2097-2105 CONGRESS STREET

2105 Congress Street—Building permit for alterations to dwelling for H. O. Washburn  
by Robert E. Swett - 9/26/56

Location--2105 Congress St.,  
Owner--Russell O. Washburn  
Job--Enclosed breezeway and garage

WILFRED BEAUDETTE & ASSOCIATES  
CHAMBERLAIN RESIDENCE  
CONGRESS ST.

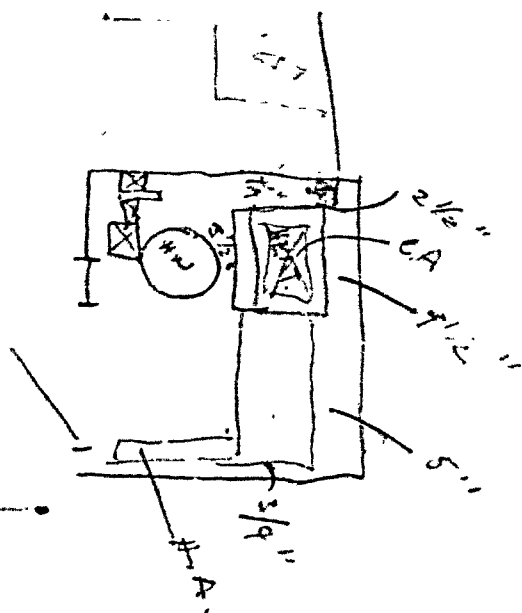
A check of the plans filed with the application for a building permit for construction of a one family dwelling at 2097-2105 Congress Street, this City, raises the following questions as to compliance with Building Code requirements:

- ✓ 6. Foundation for concrete platform outside of front door is required to extend at least 4' below grade if it is to be attached to the foundation wall of the dwelling or if it is to support the planting screen if that structure is to be fastened to the building.

- ✓ 8. The small heater room at the center of the building raises a number of questions which need to be settled now rather than later after the building has

9. How and of what material are the thin partitions shown on the plans to be constructed?

It is necessary that information be furnished on revised plans to show compliance with building Code requirements before the general construction permit may be issued.
